**(1<sup>st</sup> Draft) Final Report - Chapters 1 to 4**  
**US Access Board**  
**Rail Vehicles Access Advisory Committee**  
**March 19, 2015**

**(4/15/15 Changed by adding comments and draft Chapter 5)**  
**(4/21/15 Changed by adding additional comments)**

**Overall Review Note:** Strikeouts and underlines are used in Chapters 2 through 4 to reflect draft changes made to subcommittee reports by the committee at its meeting of February 26-27, 2015. Each chapter may have an additional review note to help readers understand a chapter's formatting or alert readers to other matters. The committee was asked to provide comments on this first draft by April 10, 2015, to then be reviewed at the April 23-24, 2015 committee meeting. Comments have been added to the draft after each applicable section or chapter title. At the beginning of each comment, the commenter's name is highlighted in green and bracketed by braces { }. Chapter 1 has been modified by Access Board staff using strikeouts and underlines. One comment was also added to the chapter. The hyperlinks have been deactivated in the chapters to avoid confusion over underlines but when the report is finalized and placed on the RV

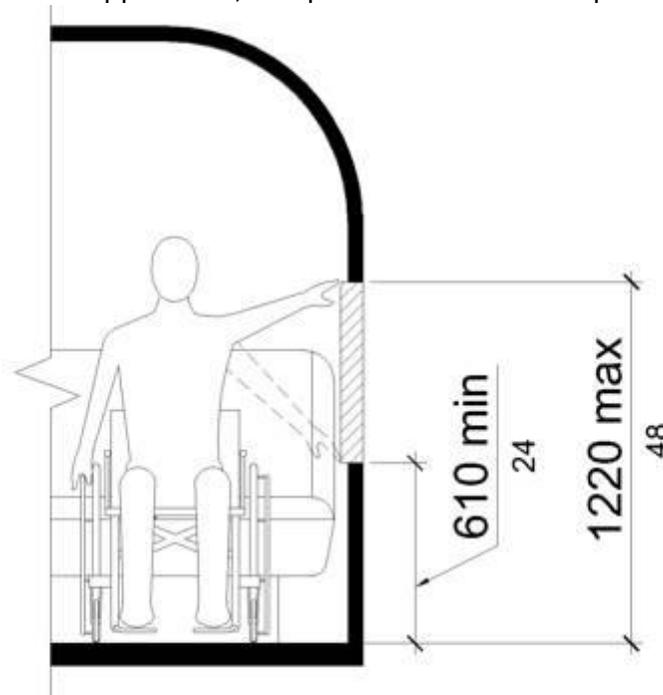
{Access Board Comment}. Figure is from where? Any restrictions on its use?
